North Carolina Department of Environment and Natural Resources

Division of Waste Management

Re: Groundwater Assessment at the Johnston County Municipal Solid Waste Landfill and proposed C&D area. Permit No. 51-01.

RE: Piezometer Removal and Ground Water Assessment Summary
Johnston County Landfill
Smithfield, North Carolina

WELL LOCATION MAP

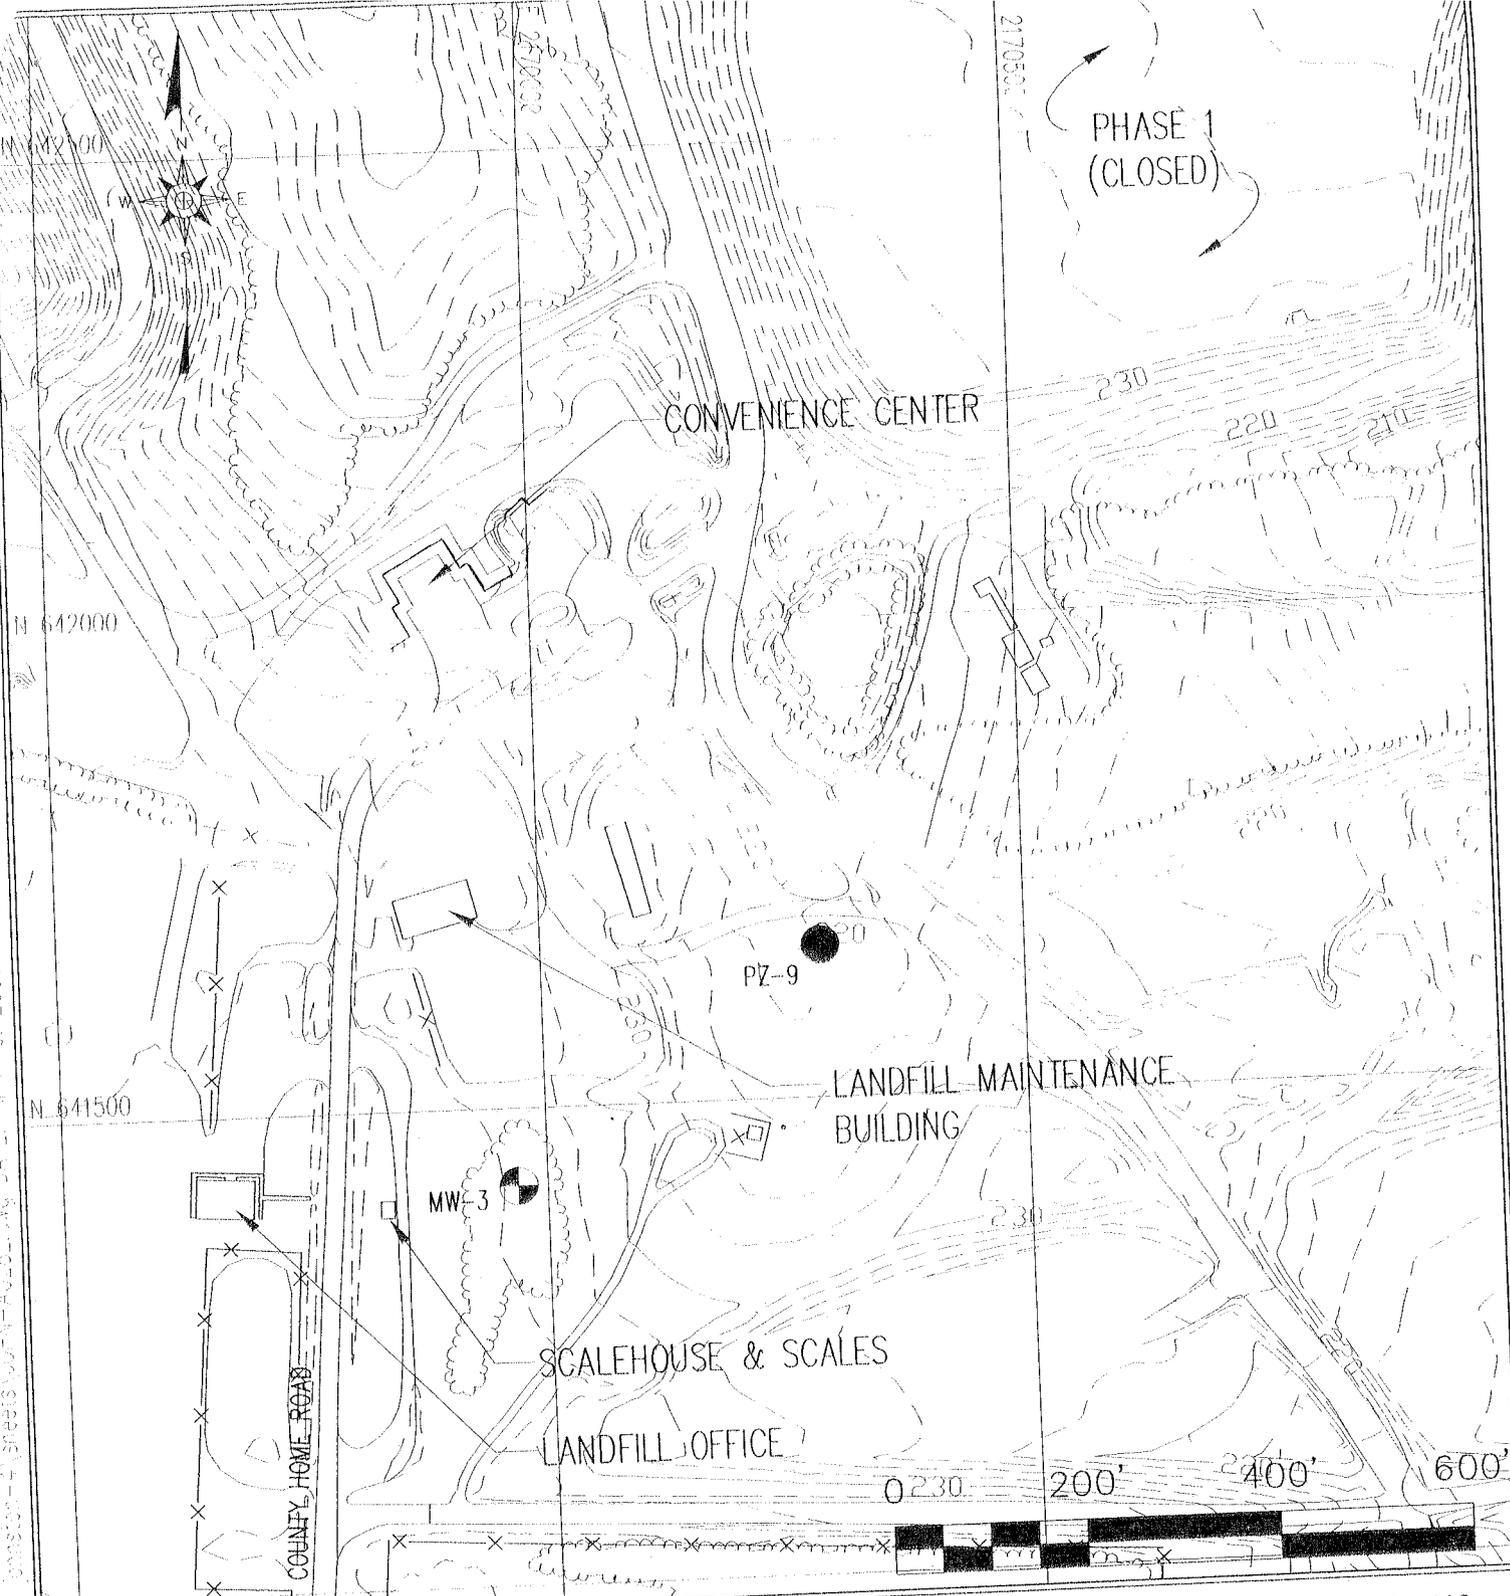
During our recent phone conversation, a piezometer has been accidentally removed at the Johnston County Landfill. This piezometer (PZ-9) was located outside Borrow Area "B" along the entrance road. A map showing the piezometer location is included as **Figure 1**. This piezometer was originally installed to evaluate borrow area "B" and its surrounding area for useful materials and water levels. This piezometer has not been monitored for water level since the permitting of this borrow area. This piezometer is not part of the ground water monitoring network due to its distance from the landfill and the fact that there is no ground water impact from the landfill in this area.
